FI SYSTEM AND INTAKE AIR SYSTEM

FUEL SYSTEM

FUEL RETURN HOSE

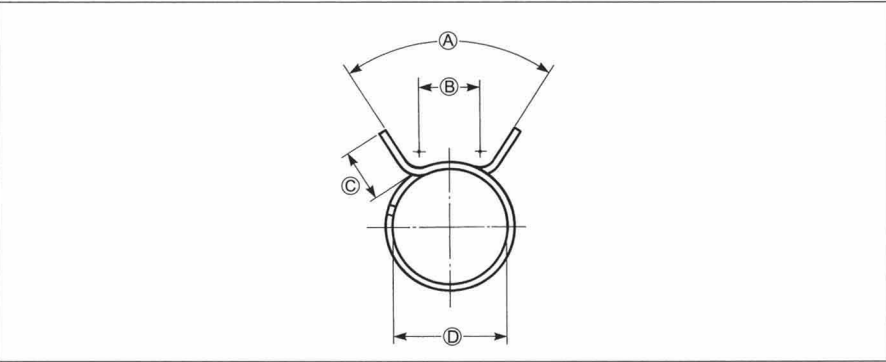
The shape of the fuel return hose has been changed. In accordance with this change, the fuel return hose clamps and dot mark color on the fuel return hose have been changed as follows.

PART NAME	1999-MODEL		2000-MODEL	
	PART NO.	DIMENSION	PART NO.	DIMENSION
HOSE CLAMP (TANK SIDE)	09401-11407	(A) 62°	09401-12405	(A) 60°
		(B) 6.2 mm		(B) 4.5 mm
		(C) 6 mm		(C) 12 mm
		(D) 11.6 mm		(D) 11 mm
HOSE CLAMP (PUMP SIDE)	09401-13417	(A) 65°	09401-14404	(A) 73° 30'
		(B) 7 mm		(B) 9.1 mm
		(C) 6 mm		(C) 6 mm
		(D) 13.2 mm		(D) 14.5 mm

FUEL FEED HOSE

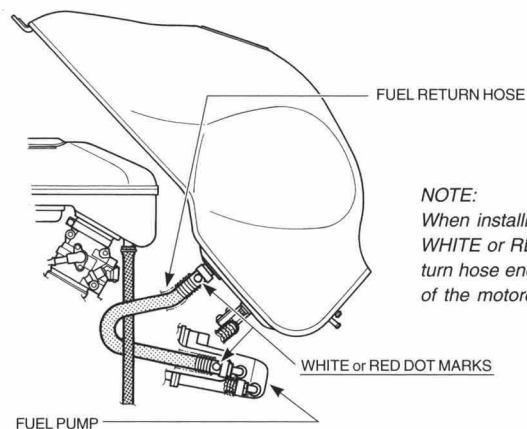
Fuel feed hose length (A)

1999-MODEL	2000-MODEL
235 mm (9.3 in)	205 mm (8.1 in)

The fuel feed hose clamp has been eliminated.
